**Re: Defect Information Report – Supplemental Report No. 2
09V-219, FL-#552 Emergency Exit Window Release Mechanism**

Subject: RECALL 09V-219 – Emergency Exit Window Release Mechanism

MODEL: MINOTOUR

SUBJECT: EMERGENCY EXIT WINDOW RELEASE MECHANISM

FIGURE 1 - LOW-FORCE ACCESS REGION FOR EMERGENCY EXITS HAVING ADJACENT SEATS

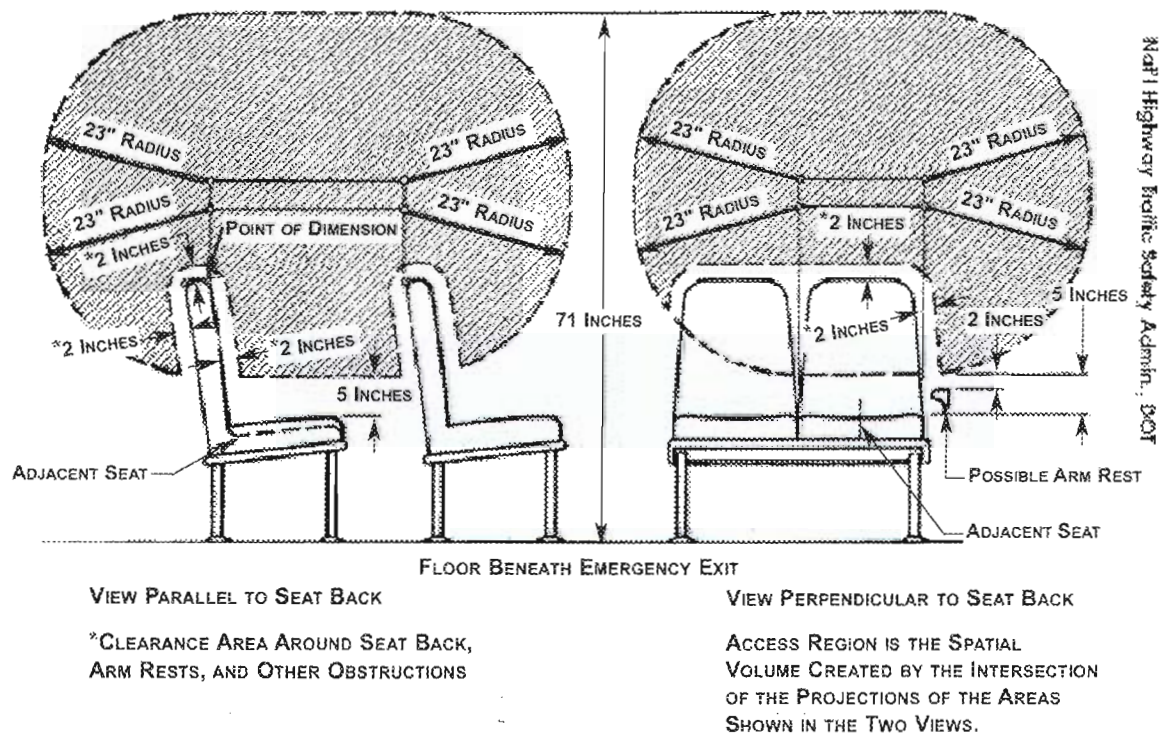
A minimum of two inches is required between an emergency push-out release handle and the adjacent seat. Check to see if your push-out window release handles are within the two inch minimum requirement.

If the handles have two inches or more clearance to the closest portion of the seat, action is not required.

If the handles are closer than two inches to any portion of the seat, continue with this repair. **Figure 1**

FIGURE 2

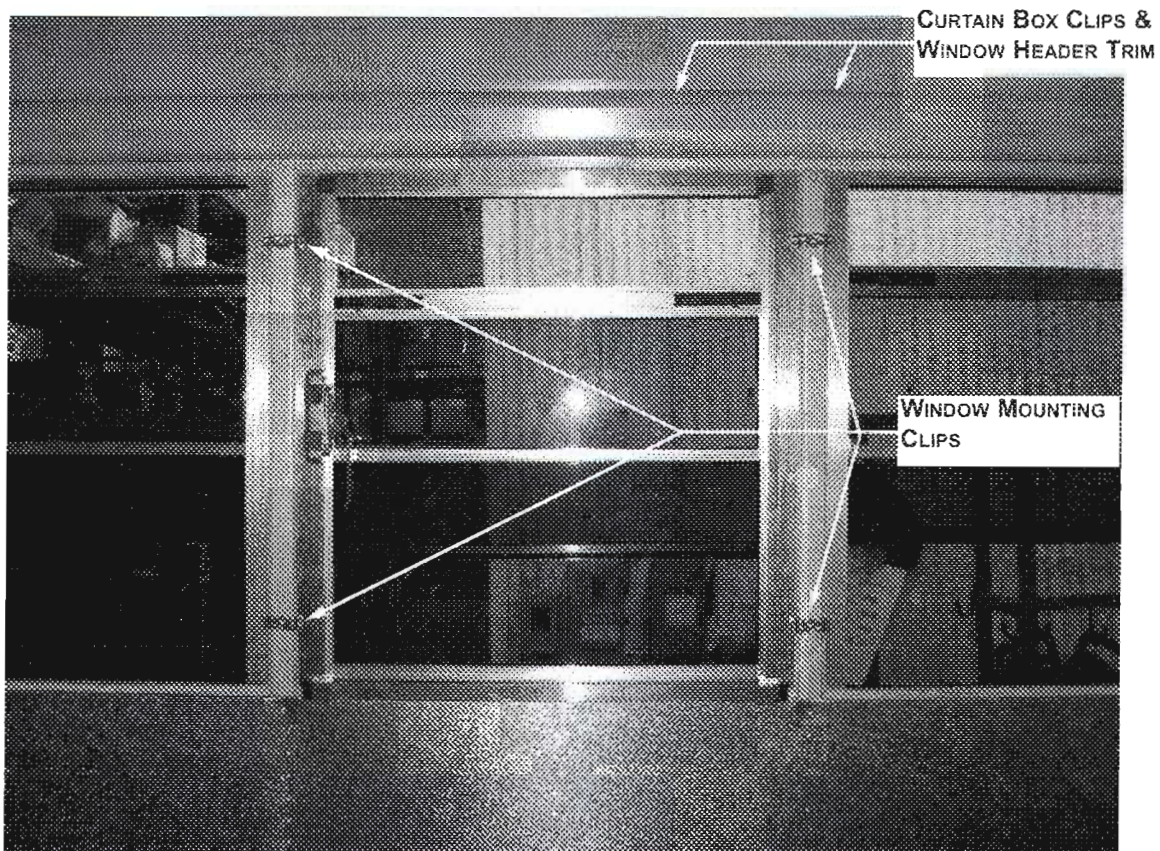
1. **IMPORTANT:** Before you begin relocating the Push-out window, verify that the new location will have the minimum two inches of clearance required between the release handle and the closest part of the seat.
2. Remove the curtain box clips and window header trim. **Figure 2**
3. Remove the four window mounting clips that retain both windows in the openings.

FIGURE 4

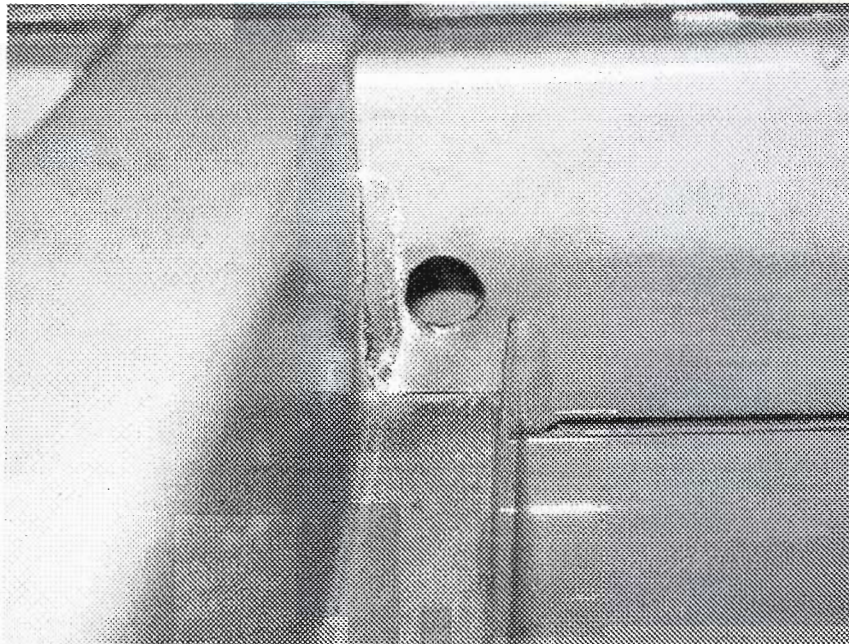
7. Lift the windows up and out of the openings.
8. Cut away any remaining raised sealant that may interfere with reinstalling the windows. Check the opening and window frame.
9. Inside the pilaster flange, on the handle side of the window, **(taking care to keep drill from contacting any wiring that may be above the window header)** drill a 0.375 dia. hole in the header of the new push-out window location. Figure 4

FIGURE 5

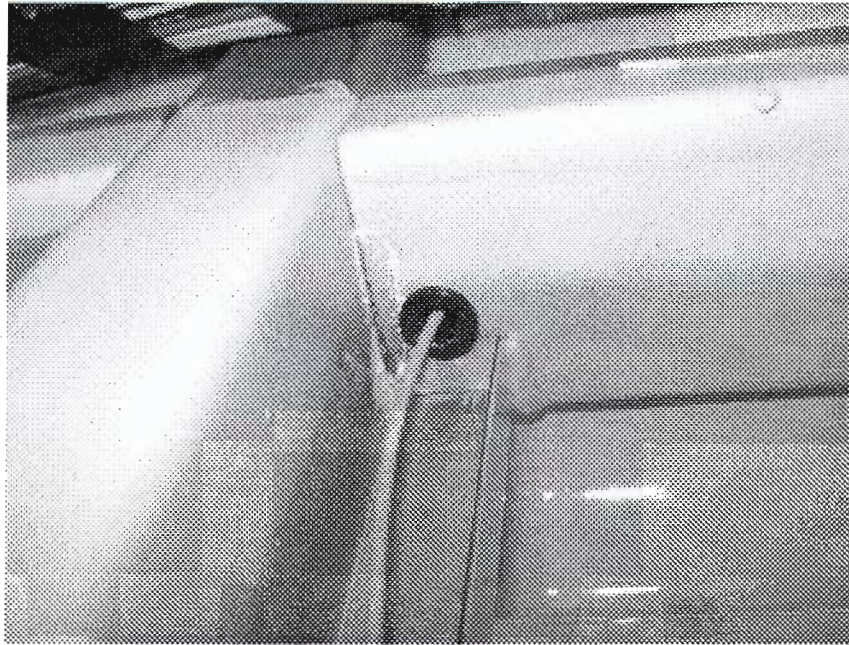
10. Insert Grommet, #TBB 22010379 into the 0.375 dia. hole from the bottom.
11. Route push-out switch wire from harness, down through the grommet at the new location. If the new location for the push-out moved toward the rear of the unit, use a Butt Splice, #TBB 22009377 and 18 GA. Wire, #TBB 163818 for the added length and route down through grommet. **Figure 5**

FIGURE 1

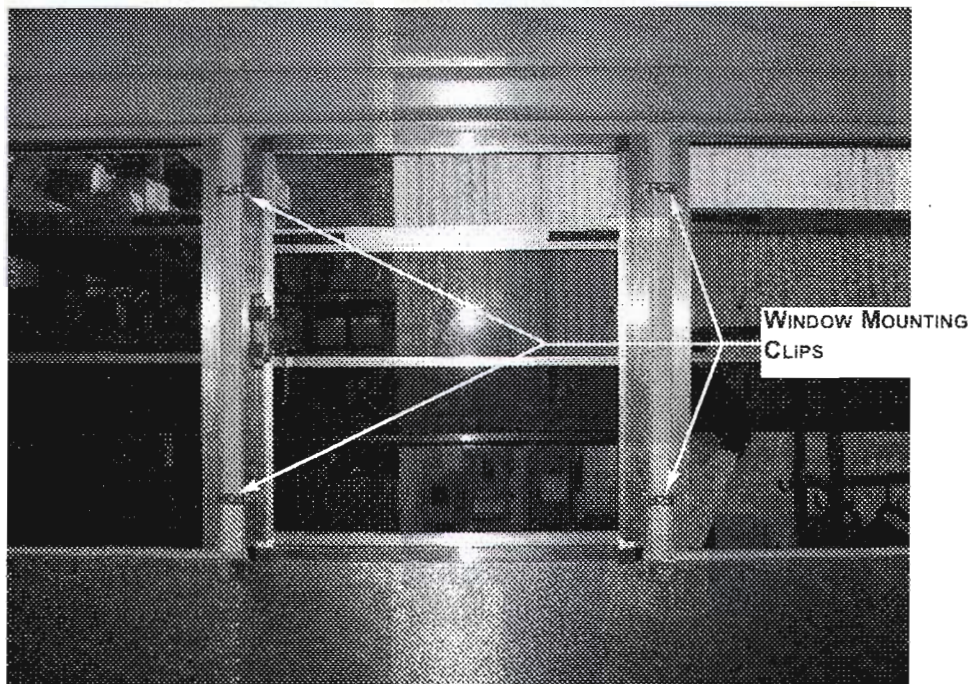
When the vertical push-out window can not be relocated, it may be replaced with a horizontal push-out window or a vertical push-out with the handle reversed. State specification should be considered.

1. Remove the four (4) window mounting clips that retain the window in the opening; retain. **Figure 1**

FIGURE 2

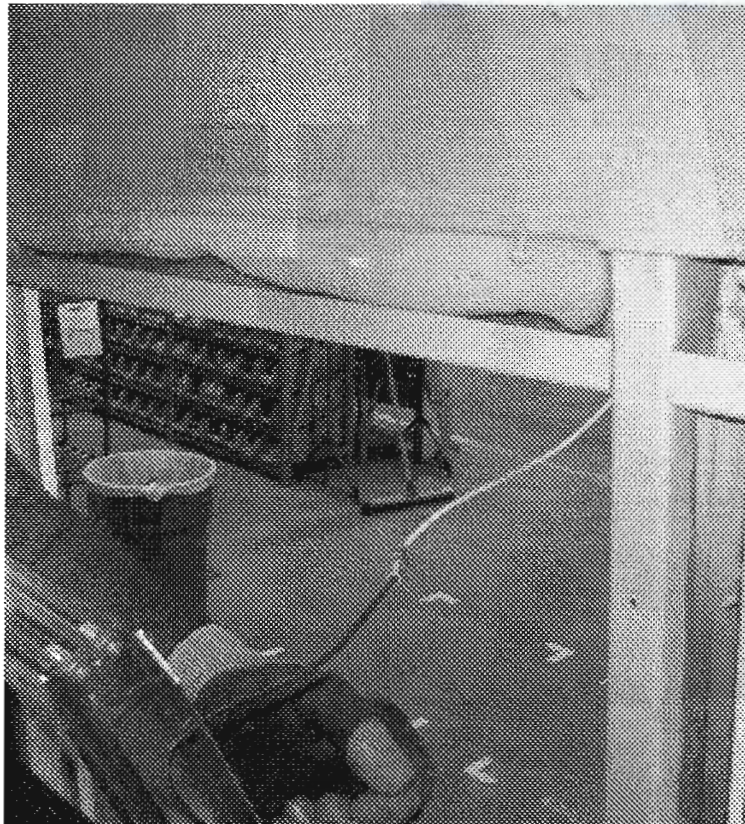
3. Lower the slider sash. Pull the top of the window frame inside the unit, so that the top of the frame clears the window header.
4. Cut the push-out window switch wire at the splice. **Figure 2**

FIGURE 3

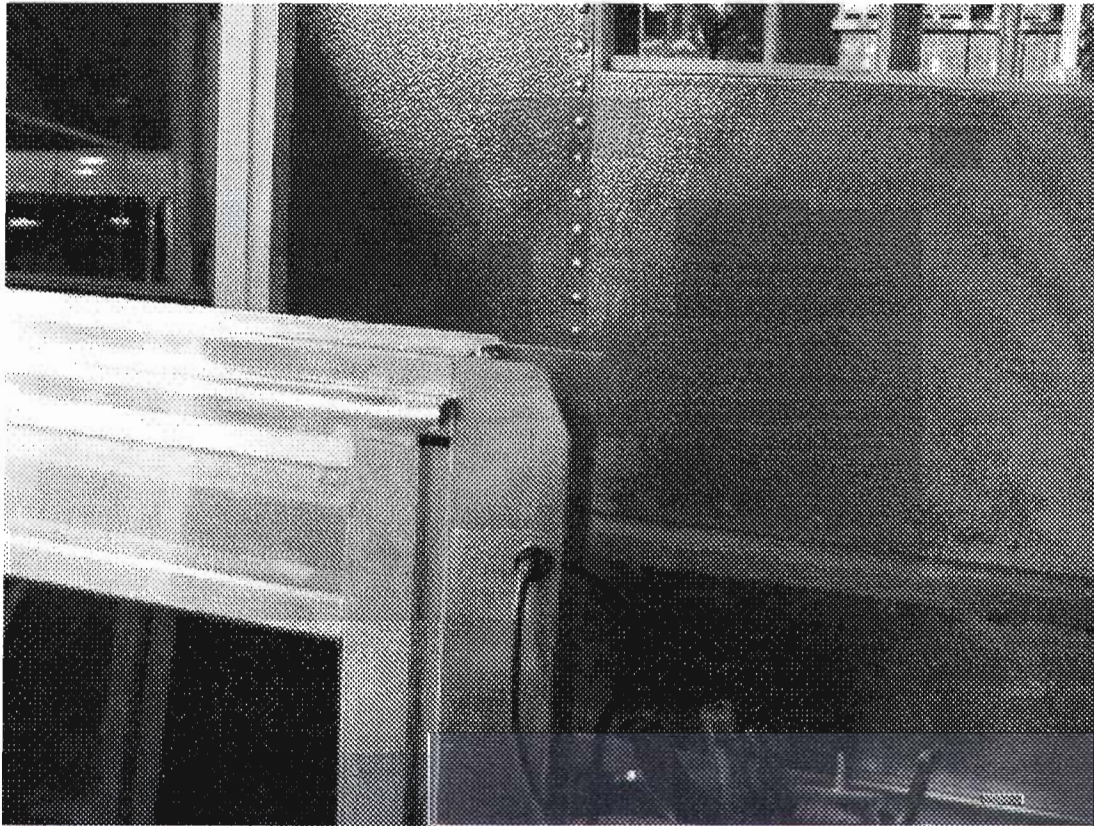
5. Lift the window up and out of the opening.
6. Cut away any remaining raised sealant that may interfere with reinstalling the window. Check the opening and window frame.
7. On the switched / wiring side of the window, using snips, cut an approximately $\frac{1}{2}$ " X $\frac{1}{2}$ " chamfer on the outer, top corner of the window frame. This creates clearance for the wire and grommet pass-through in the header. **Figure 3**
